Item Name: Crosstube Assembly, Mid Fwd

DART AEROSPACE LTD		Work Order: 96761
Description: Crosstube Assembly, Mid Fwd		Part Number: D206-667-147TRN
Inspection Dwg: D206-667-147 Rev: A		Page 1 of 2

DRAWING NO. D206-667-147	TITLE CROSSTUBE ASS'Y (206L MID FWD)	REV. A	DART AEROSPACE LTD ENGINEERING ORDER		D.E.O. NO. D206-667-147-A-1	SHEET NO. SHEET 1 OF 1	SCALE NTS
DRAWN <i>qp</i>	CHECKED <i>AS</i>	MFG. APPR. <i>AS</i>	APPROVED <i>MD</i>	DE APPR. <i>MD</i>			
DATE 11.07.15	DATE 11.07.20	DATE 11.07.21	DATE 11/07/21	DATE 11.07.21

DRAWING NO. D206-667-147	TITLE CROSSTUBE ASS'Y (206L MID FWD)	REV. A	DART AEROSPACE LTD ENGINEERING ORDER		D.E.O. NO. D206-667-147-A-2	SHEET NO. SHEET 1 OF 1	SCALE NTS
DRAWN AJS	CHECKED	MFG. APPR.	APPROVED		DE APPR.		
DATE 12.08.02	DATE 12.08.02	DATE 12.08.02	DATE 12.08.02		DATE 12.08.02	DATE 12.08.02

DETAIL P
BONDING STRAP INSTALLATION 2 PL

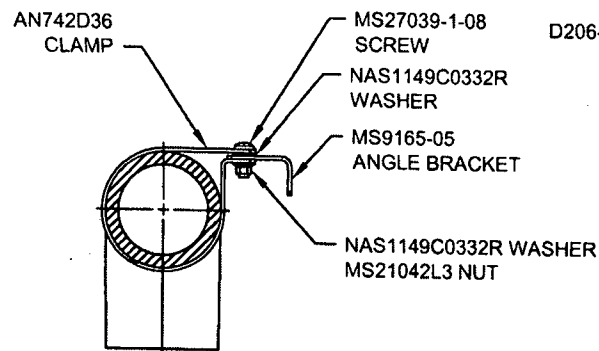
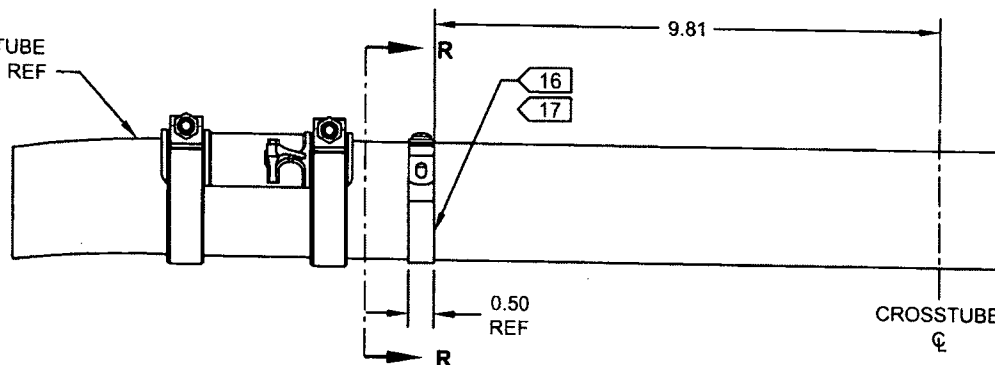
PURPOSE:

ADD ELECTRICAL GROUNDING STRAP

ITEM	QTY -147	PART NUMBER	DESCRIPTION
1	X	D206-667-147	CROSSTUBE ASSEMBLY (206L MID FWD)
10	2	AN742D36	CLAMP
11	2	MS9165-05	ANGLE BRACKET
12	2	MS21042L3	NUT (OR MS21042-3)
13	2	MS27039-1-08	SCREW
14	4	NAS1149C0332R	WASHER (OR AN960C10L)

- 16) MASK AREA UNDER CLAMP PRIOR TO PAINTING
 17) SEAL EDGES WHERE AN742D36 CLAMP MEETS WITH THE CROSSTUBE USING SIKAFLEX-241/291 OR MIL-S-8802 CLASS B2 OR PROSEAL 890 SEALANT
 18) PERFORM RESISTANCE CHECK TO ENSURE MAX RESISTANCE IS 10 MILLIOHMS
